**Advisory Action
Before the Filing of an Appeal Brief**

09/812,437

BIRRU, DAGNACHEW

Fig. 3

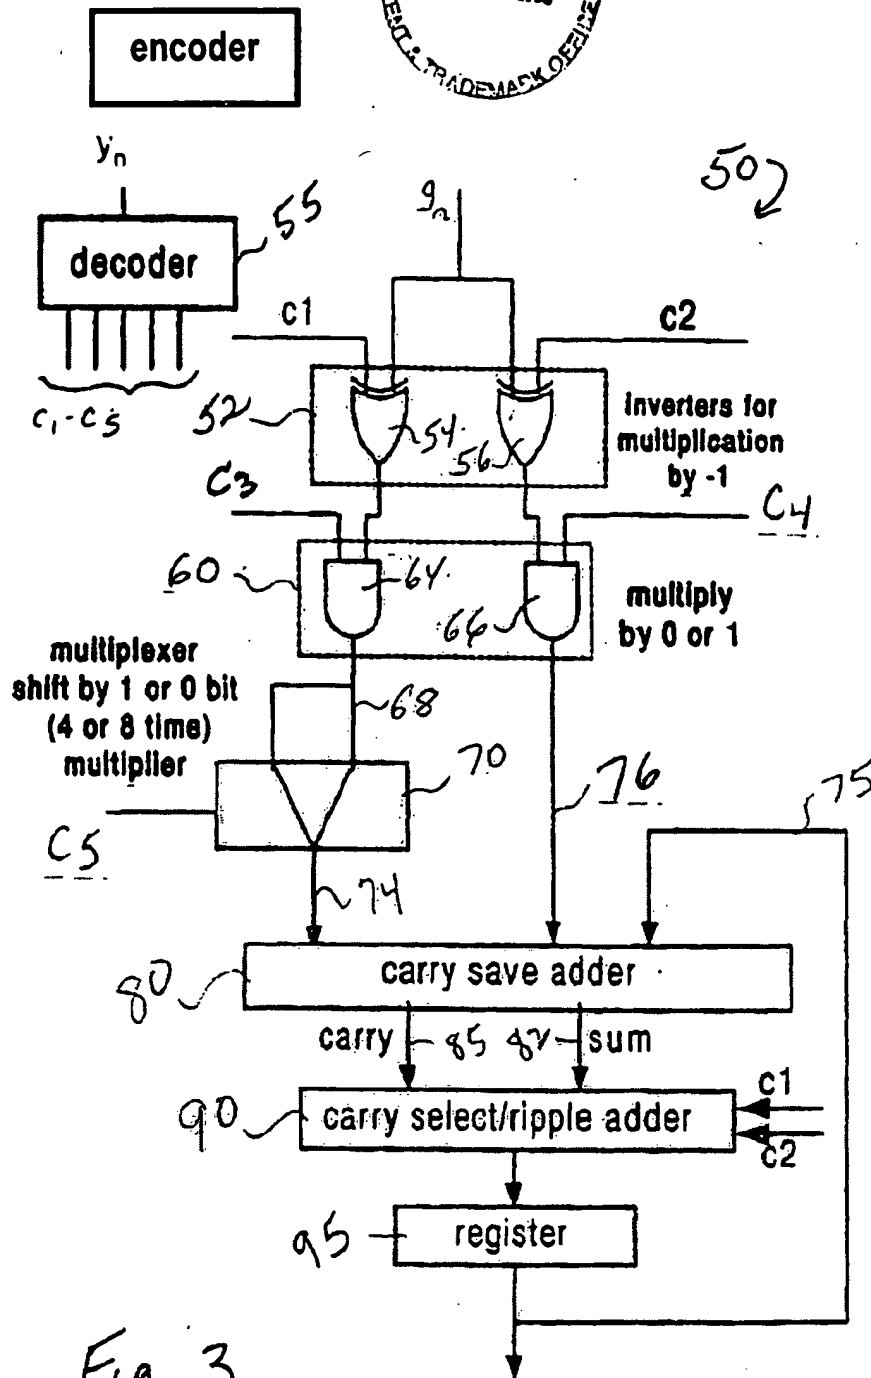
1. The drawings were received on August 8, 2005. These drawings are not accepted because the detailed description does not include a description of the encoder that was added to Figure 3. It is unclear how the encoder interfaces with the other elements of the circuit.

multiplication circuit" to a combination of an XOR gate and an AND gate (e.g. "54" and "64" form one sub-multiplication circuit) since the "filter coefficient" is inputted only to the XOR gate wherein XOR gate multiplies the filter coefficient by "a negative value" (see "inverters for multiplication by -1" in Figure 3) and multiplication by "a positive value" or "zero (0)" corresponds to an AND gate.

Not accepted
